Plan Holders of: **Headworks Bar Screen 1 Replacement, Project CIP 74170**

Subject: Addendum No. 3

ADDENDUM NO. 3

MCC-HDW ONE-LINE DIAGRAM (PARTIAL)

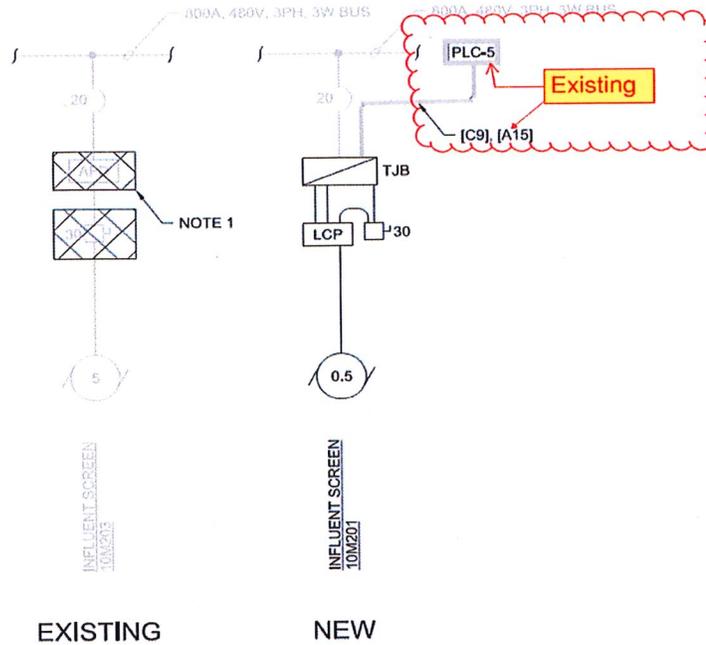
Item No. 1: Volume 3, Drawings, Sheet 41-E-110

Question: Sheet 08-N-005 shows PLC-5 is existing, but sheet 41-E-110 shows the PLC-05 in "bold", indicating it is new. Please confirm PLC-5 is existing, not new?

Question: Sheet 41-E-110 MCC-HDW One-line Diagram (partial): Please confirm the conduits for circuits [C9] and [A15] shown to run from the TJB to PLC-5 already exist within the underground duct bank system. If the conduits are intended to be new, provide routing?

Answer: PLC-5 shown on MCC-HDW ONE-LINE DIAGRAM (PARTIAL) is existing.

MCC-HDW ONE-LINE DIAGRAM (PARTIAL) have been modified as shown in the following.

Answer: That is correct. Buried Conduits for circuits C9 and A15 exist from PLC-5 to the new TJB (supply and installation of new TJB is part of the proposed project). Refer Item No.1.

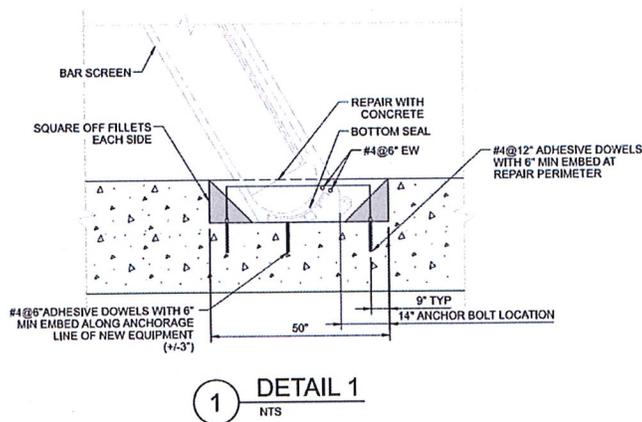
Question: Please elaborate on the extent of the new concrete required for the bar screen recess on 10-D-301. Are we just adding the fillets? Are we adding the anchors? How much concrete is to be added? Can you please provide dimensions?

Answer: As shown below Detail1 on Sheet 10-D-301, Volume 3 Drawings shows existing fillets need to be squared off and then install dowels and fill with concrete. Approximate dimensions of new concrete are 50 inches long, 36 inches wide and 12 inches deep.

DESIGNER	JMH	DATE	2/18/2022
CHECKED		DATE	2/18/2022
APPROVED		DATE	2/18/2022
TITLE	SUB-ASSY: VERTICAL SUPPORT 316SS		
FORM NO.	3792.S.VRS1.6.0.0		
REV.	0		
DATE	T-4		
SHEET	1 OF 1

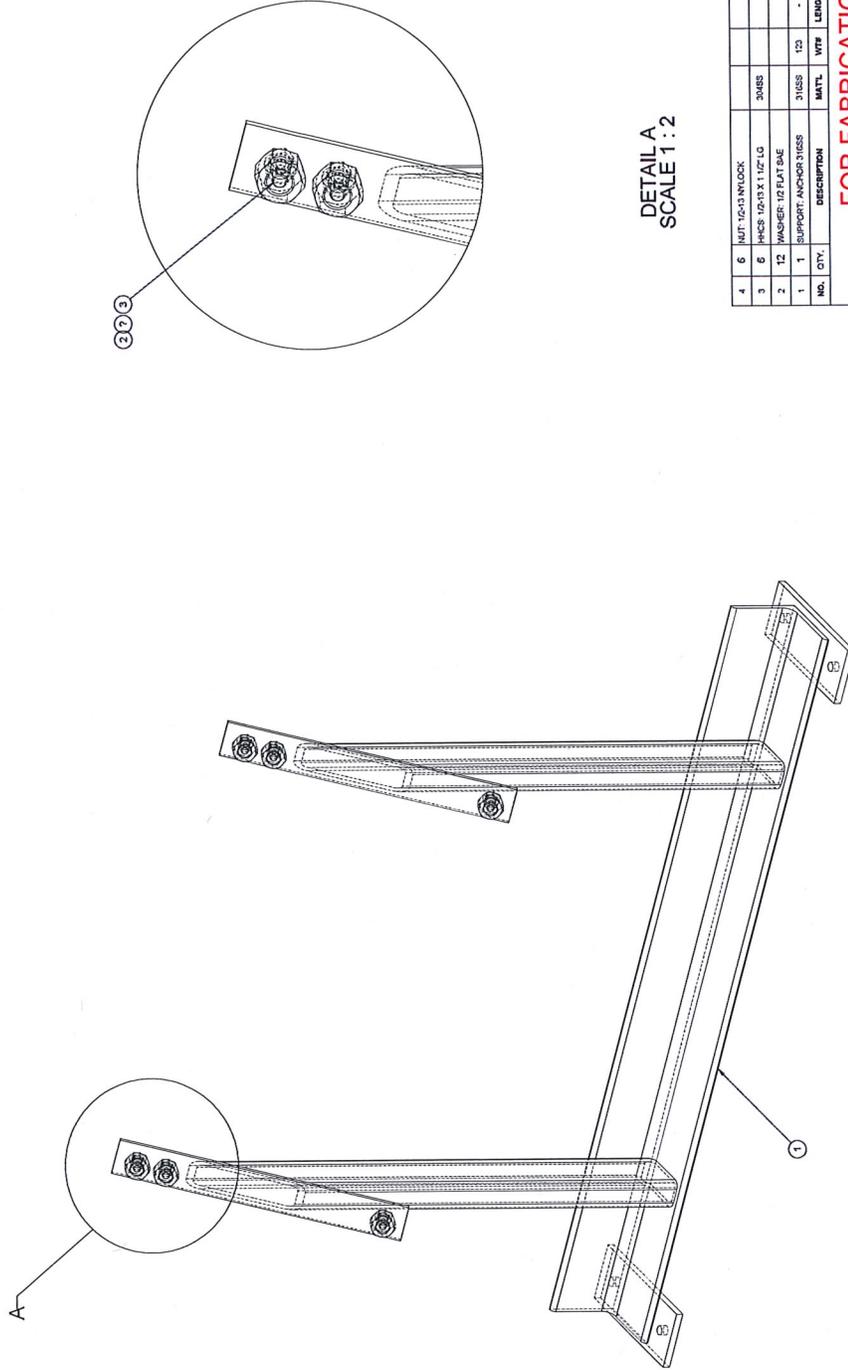
Question: Is there any vertical mounting along the sides of the bar screens?

Answer: Yes, there is vertical support along the sides of the bar screen, see attached drawing to this addendum.
